**Landmarks & Urban
Conservation Commission**

**Agenda Number: 6
Case No.: 16-LUCC-50031
Project # 1010928
August 10, 2016**

Staff Report

This application is for alterations to the roof through the addition of surface mounted solar panels. This request was reviewed against the relevant guidelines for the Fourth Ward Historic Overlay Zone and the criteria for approval of a Certificate of Appropriateness. The proposal is generally consistent with the guidelines and the criteria, as they encourage the use of energy saving technologies, however; the placement location of the panels might be improved. The proposed alterations will affect but not detract from the historic and architectural character of the Fourth Ward Historic District.

PV - SITE PLAN

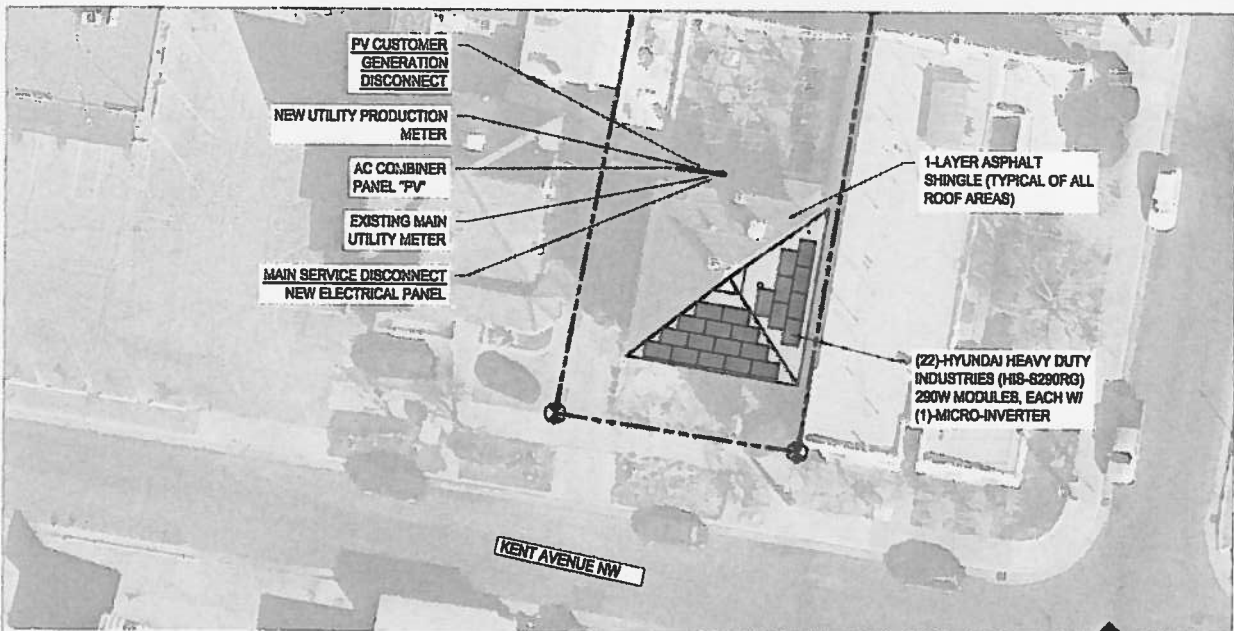
The current panel layout does not conform to the guidelines, as it utilized the front face on the south side of the building for the placement of 14 PV solar panels.

Although the solar panels are low profile they are still visible from the main street and are not in accordance with the guidelines.

1. Applicant is responsible to acquire, and approval is contingent upon, approval of all applicable permits and related approvals.
2. Final placement of solar panels shall be relocated from the front roof plane and subject to review and approval by LUCC staff.

PV - SITE PLAN

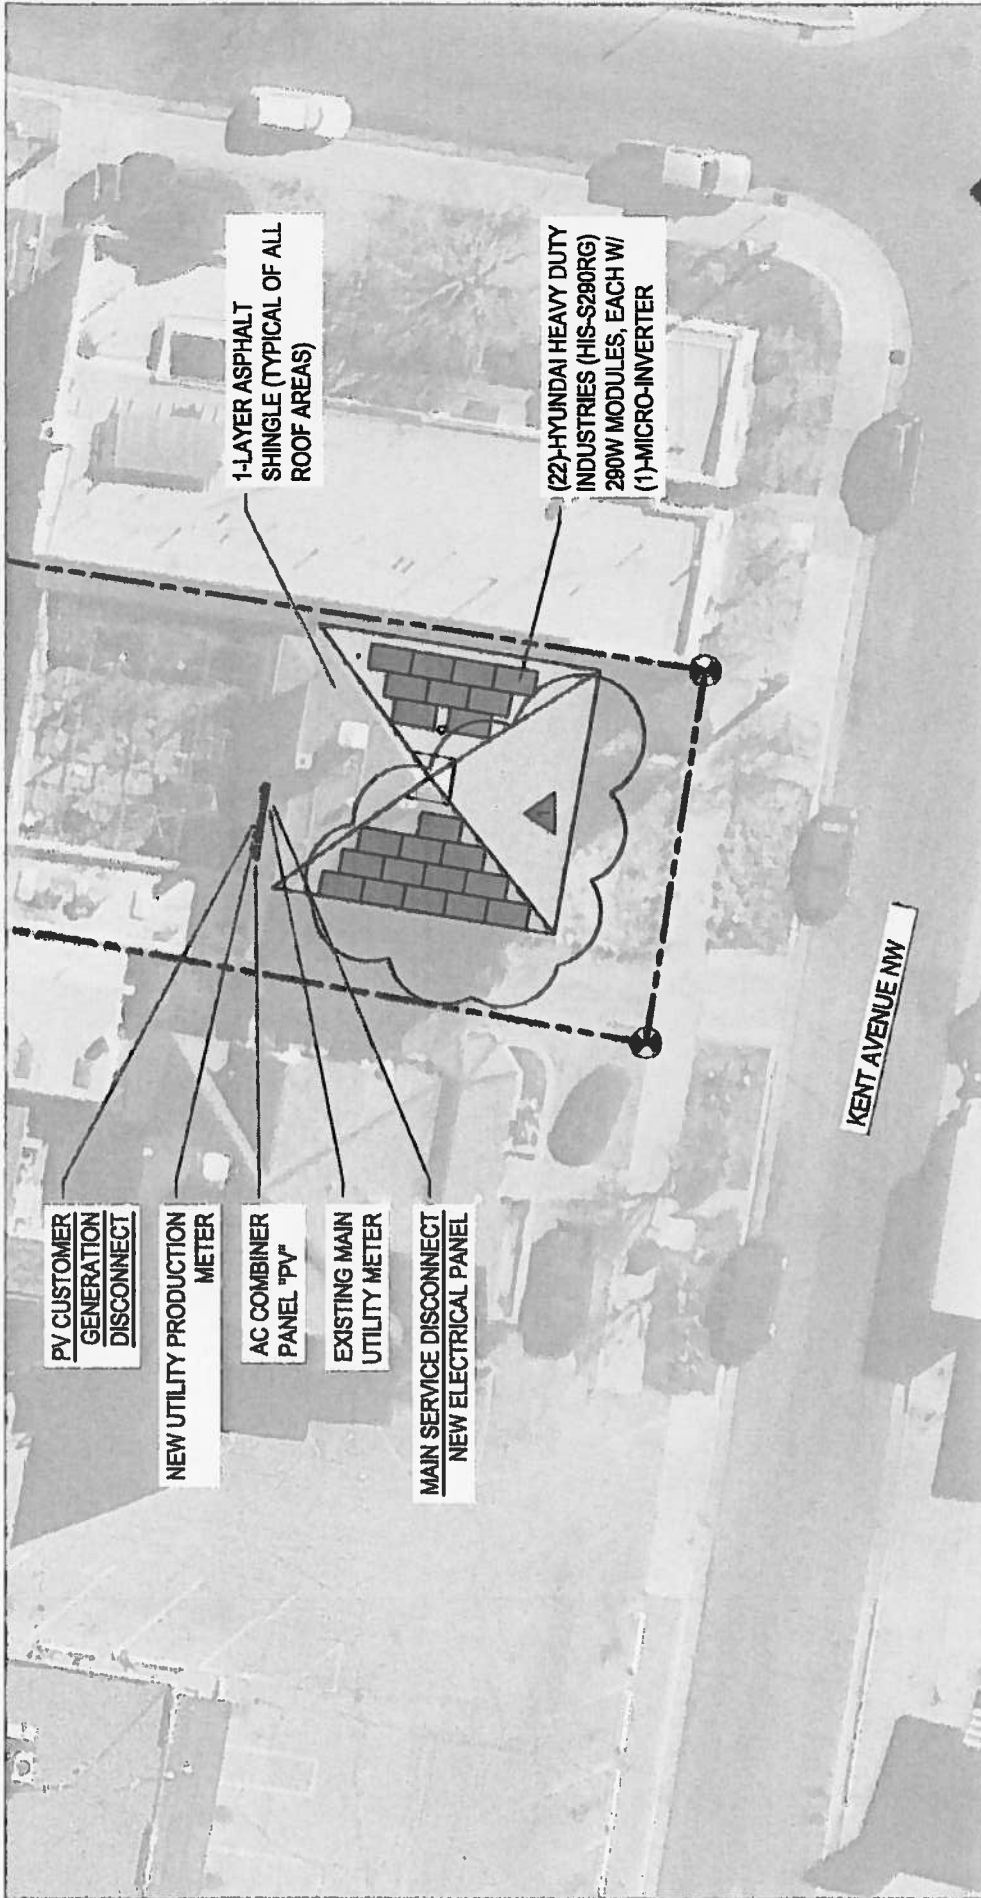
This request for a Certificate of Appropriateness for alteration has been reviewed against the relevant guidelines for the *Fourth Ward Historic Overlay Zone* and the criteria for approval of a Certificate of Appropriateness contained in the *LUC Ordinance*. As discussed in the analysis above, the proposal is generally consistent with the guidelines and substantially consistent with the criteria for approval of a Certificate of Appropriateness. However, the placement of solar panels on the front roof plane is contrary to the Design Guidelines. Staff proposed that the client look at placing panels on the west facing roof plane to limit the impact to the street facing front elevation. Such a configuration was found to be doable but would produce an estimated 2,248 kWh less per year than the original design.
